Statement of Evidence

Reference: Macquarie Point Multipurpose Stadium
Project of State Significance

Date: 29th June, 2025

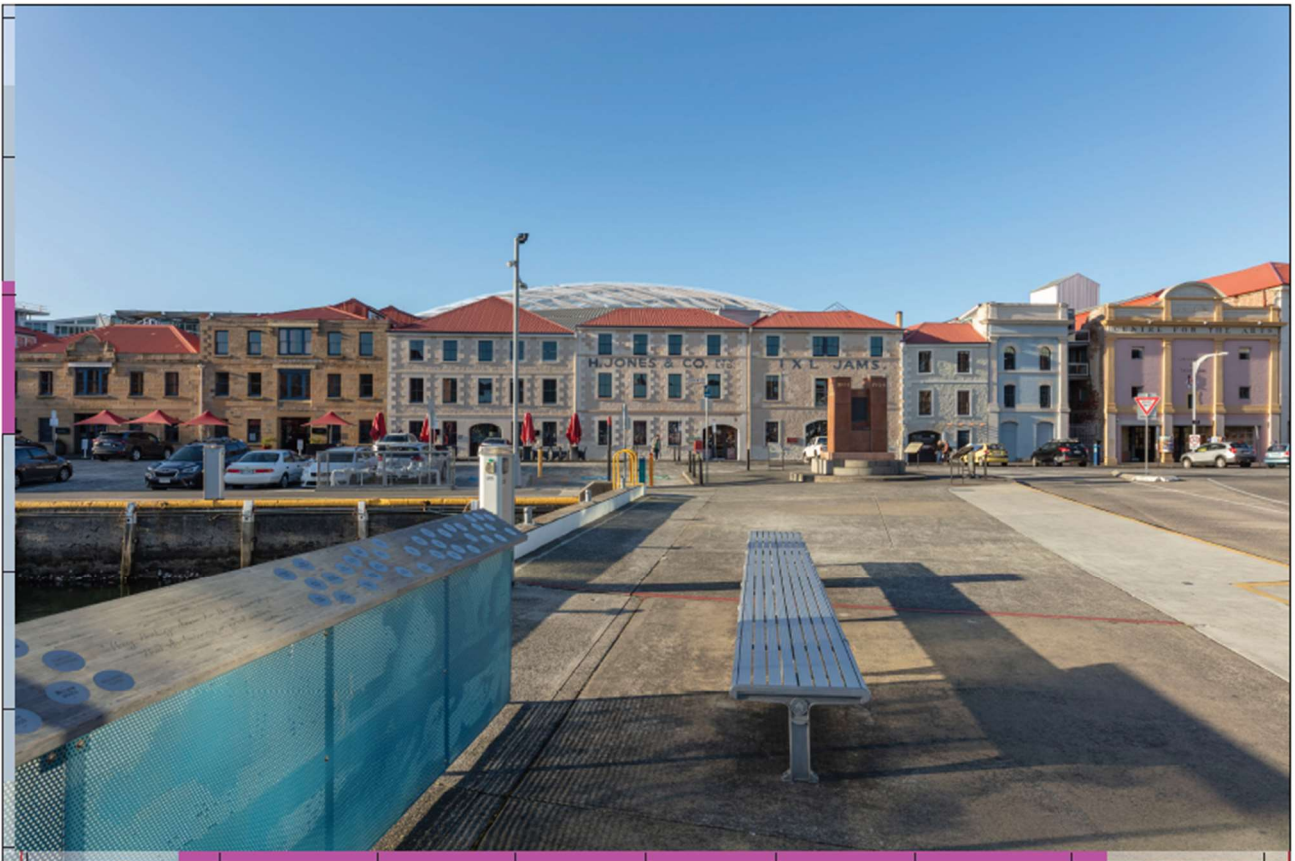
KOP 08 – viewpoint selection locates a sign in the vista that occludes a substantial portion of the stadium elevation, as well as the zero reflectivity roof blending into the hills and skyline beyond.
(20mm lens at 0.88kms from site)

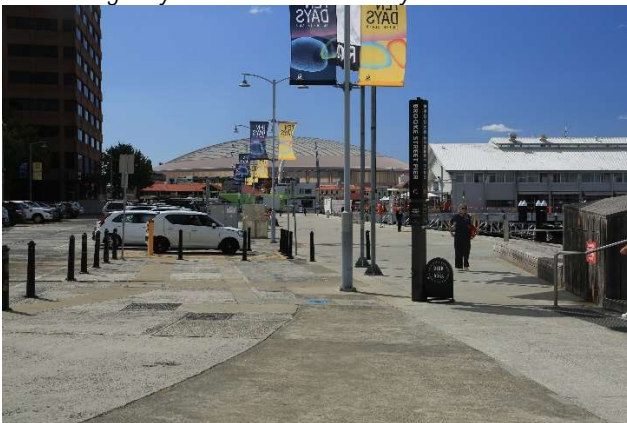
KOP 16 – stadium placed off centre to view, diminishing its visual impact and not representing the impact on the Royal Engineers Building.
(20mm lens at 0.25 kms from site.)

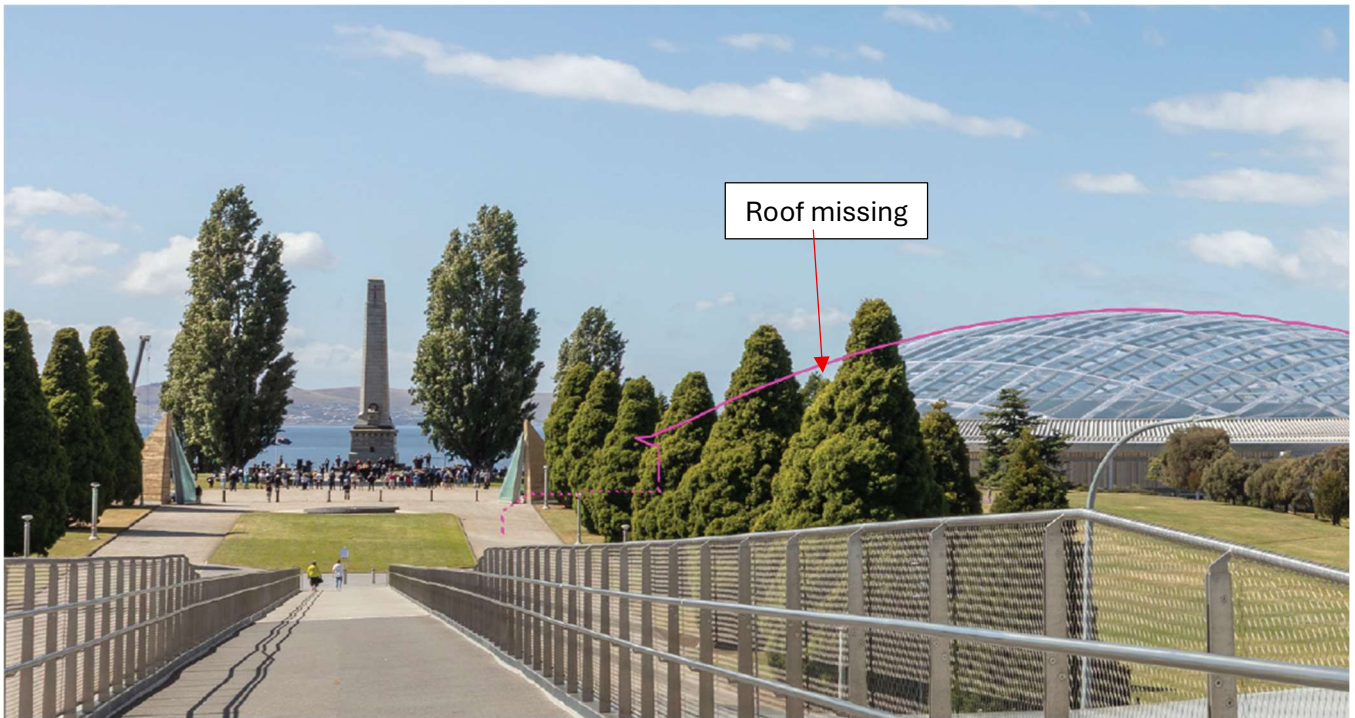
The image below is an extract of KOP 02 from the Bridge of Remembrance. The photograph was taken on Remembrance Day 2024 and shows the crowd of people gathering to remember the fallen. The existence of the stadium would significantly change the experience of the service and their visual connection to Hobart and the Derwent. The image also shows a section of stadium roof omitted from visualisation.

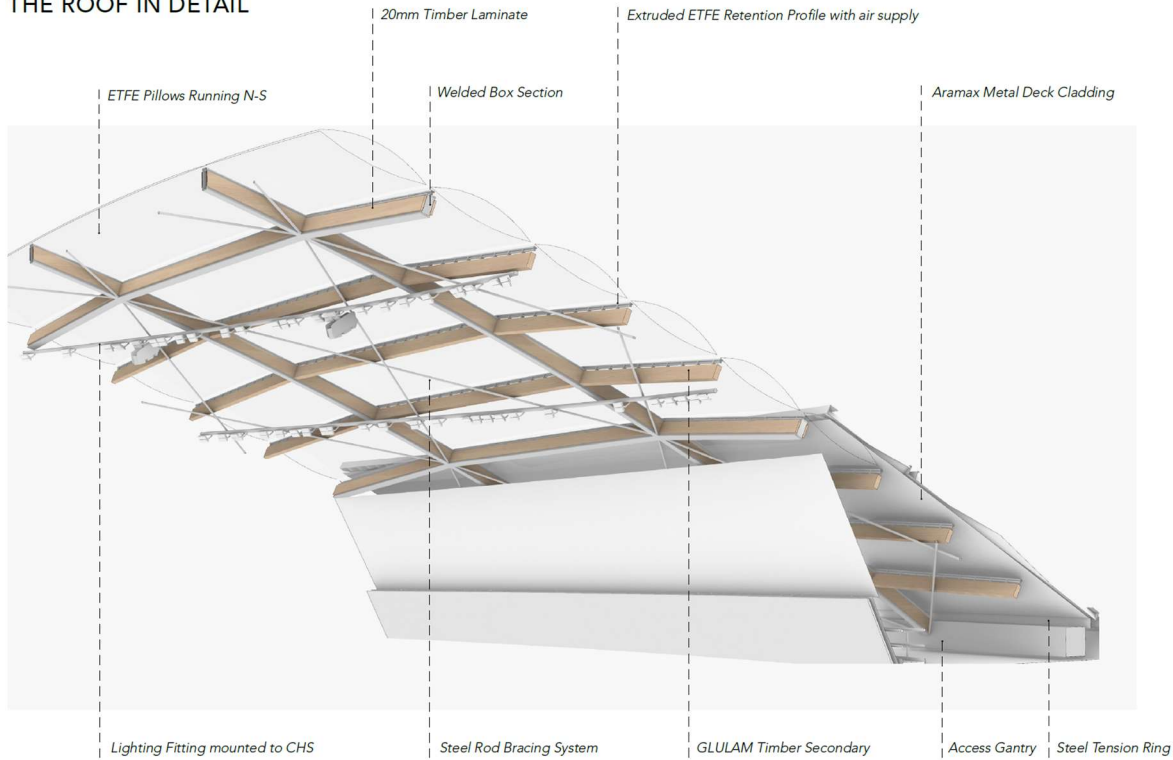
- 1 The ETFE roof is rendered as having no reflectivity. The marketing image for the material below, shows that this is unlikely to be the case:

Note also that the shape of the ETFE “pillows” means there are multiple points of reflectivity across the roof, covering more reflective extent than a flat surface would. This will increase the visual impact from ALL viewpoints presented, but particularly the elevated ones and those with a naturally darker backdrop in:

KOP 06 – the LVIA’s “activated built wall edge to Evans Street”. There is **extremely** limited “activation”.

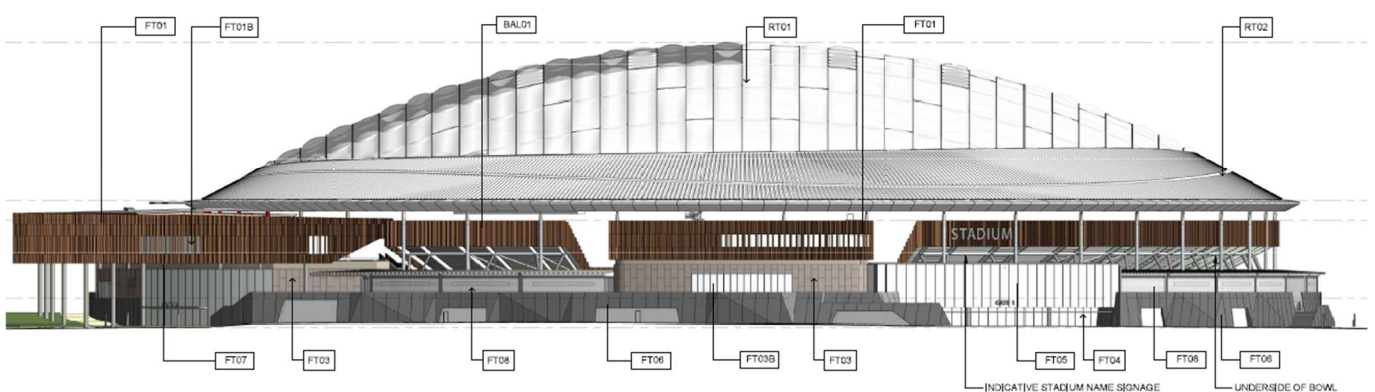
Other parts of the report adopt language that appears counter to both the architectural drawings and the photomontages. The Evans Street montage (KOP 06) describes the building as providing an “*activated built wall edge to Evans Street*” and having “*an airy, verdant embrace around the stadium*”. (p176) Below is the relevant montage:

Evans Street Elevation

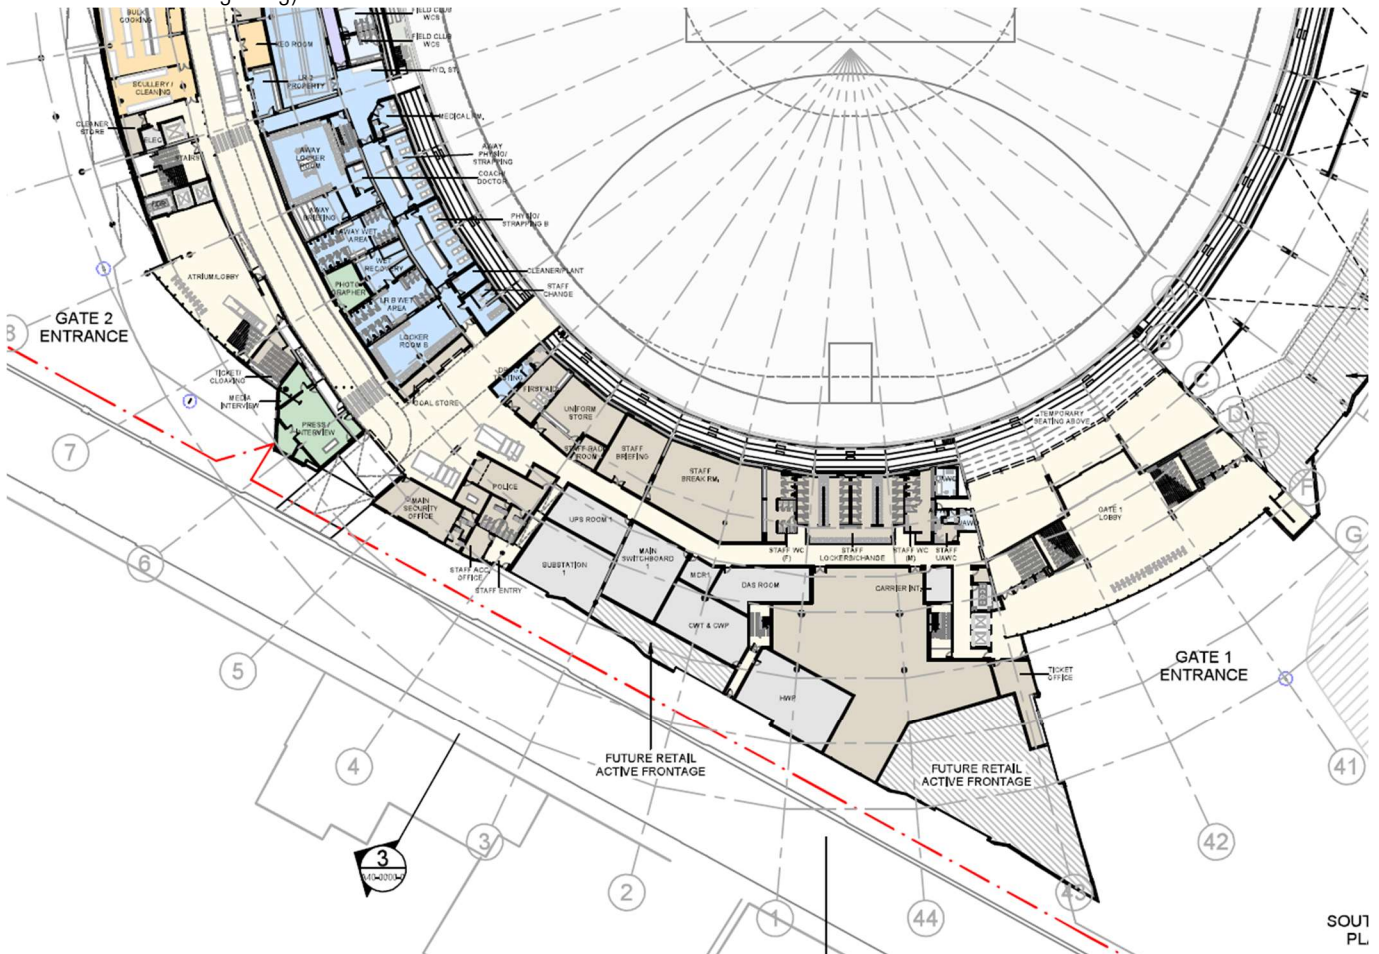
Below is the architectural elevation from Evans Street, confirming the extent of “activation” is minimal between the two Entries:
